# Pixel Cooling Fitting Failure Studies

## 2.7/3.0 Fitting with Screen

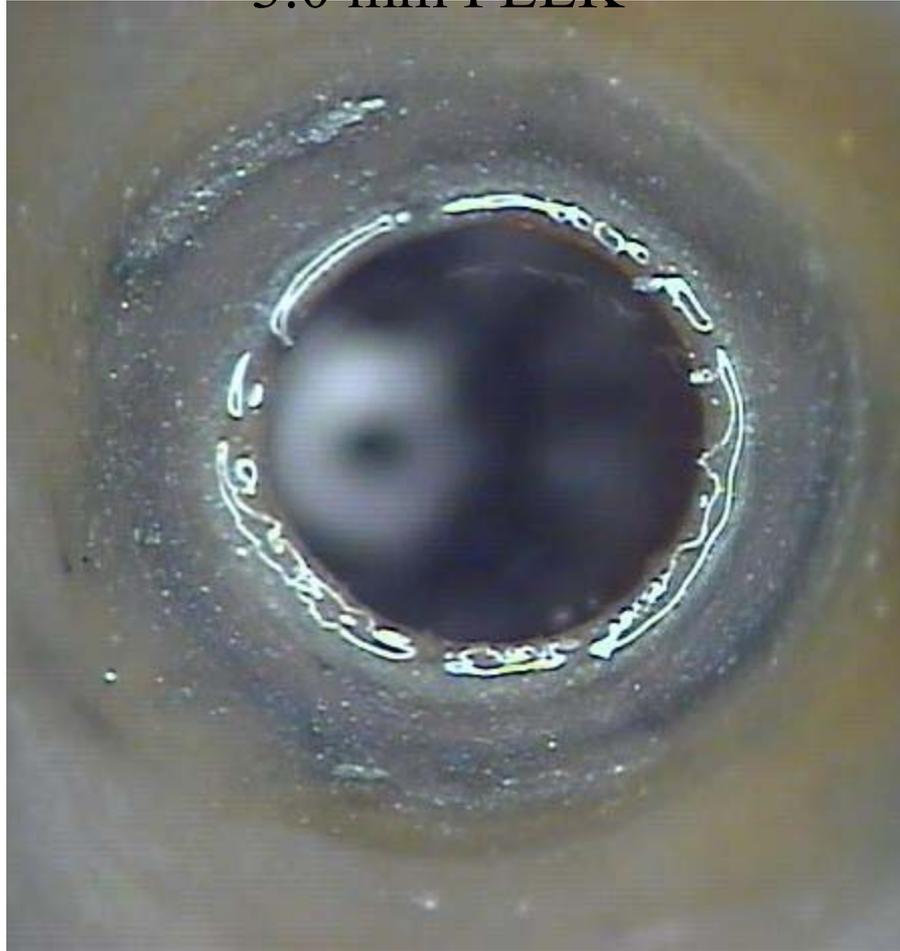
- One of the 2.7mm/3.0mm sets failed the high pressure test.
- Fred and I took it apart. The 3mm flare was clearly not done properly and made minimal contact with the PEEK insert see page 3.
- The 3 flare was not flared enough and the diameter of the flare was smaller than the 2.7mm flare. See page 4. Both pictures were taken with the same magnification.
- The 2.7mm flare was not great either. Not uniformly flared.
- The next steps are the following
  - Fred will cut off the 3mm flare and re-flare it using the same tool but taking into account experience he has with recent flaring tests on samples
  - Leave 2.7mm flare as is
  - Clean all parts again, reassemble and retest, hi pressure only.
